Access Compliance Report

Public Rights-of-Way

Intersection ID: 48560	Main Street: WOODLAND_WATCH_CT	Cross Street: ARDREY_WOODS_DR	Location: S
ADA ID: 23783CB1D98D	Ramp Type: PerpDiag	Initial Pass/Fail: Pass	Overall Compliance: No
Severity Score: 5			
Codes/Mitigation Info/Possible Solution		Field Measurements/Component Compliance

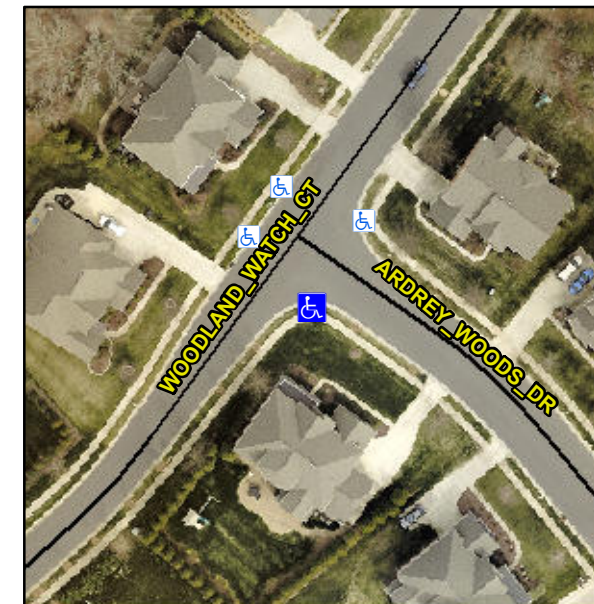
Not Found, R304.2.1, R305.2, R304.5.4

Compliance	Description	Data	Compliance	Description	Data
N/A	Ramp Length (in)	47.0	Yes	Ramp Slope (%)	6.1
Yes	Ramp Width (in)	48.0	Yes	Ramp XSlope (%)	0.1
N/A	Flare Type LT	Sloped	N/A	Flare Type RT	N/A
N/A	Flare Slope LT (%)	3.7	Yes	Flare Slope RT (%)	4.3
N/A	Flare Traversable LT?	Yes	N/A	Flare Traversable RT?	Yes
No	Landing Length (in)	47.0	Yes	DWS Provided?	Yes
Yes	Landing Width (in)	48.0	Yes	DWS Contrast?	Yes
Yes	Landing Slope (%)	0.7	Yes	DWS Length (in)	24.0
Yes	Landing X Slope (%)	0.2	Yes	DWS Full Width?	Yes
N/A	Landing Curb? (Y/N)	No	No	DWS Offset (in)	4.2
N/A	Shared Landing?	No			
Yes	Gutter Ponding?	No	No	Gutter Slope (%)	12.7
Yes	Gutter Lip Ht (in)	0.0	Yes	Gutter X Slope (%)	0.4
N/A	Painted X Walk1?	No	N/A	Painted X Walk2?	No
	X Walk 1 Direction	To NE		X Walk 2 Direction	To NW
N/A	X Walk 1 Width (in)	N/A	N/A	X Walk 2 Width (in)	N/A
	X Walk 1 Slope (%)	4.8		X Walk 2 Slope (%)	2.1
	X Walk 1 X Slope (%)	1.9		X Walk 2 X Slope (%)	5.1

N/A	Ramp inside XWalk1?	N/A	N/A	Ramp inside XWalk2?	N/A
	Road Slope (%)	0.1	N/A	Clear Space?	Yes
	Road X Slope (%)	4.9	N/A	Clear Space to XWalk (in)	N/A
Yes	Any Obstructions?	No	Yes	Storm Grate/Utility Hazard?	No
	Obstruction Type			Storm Grate/Utility Type	
		N/A			N/A
		Yes	Yes	Surface Condition? (G/P)	Good

Remove & Replace Curb Ramp With Two New Directional Ramps or Equivalent. Remove & Replace Gutter.
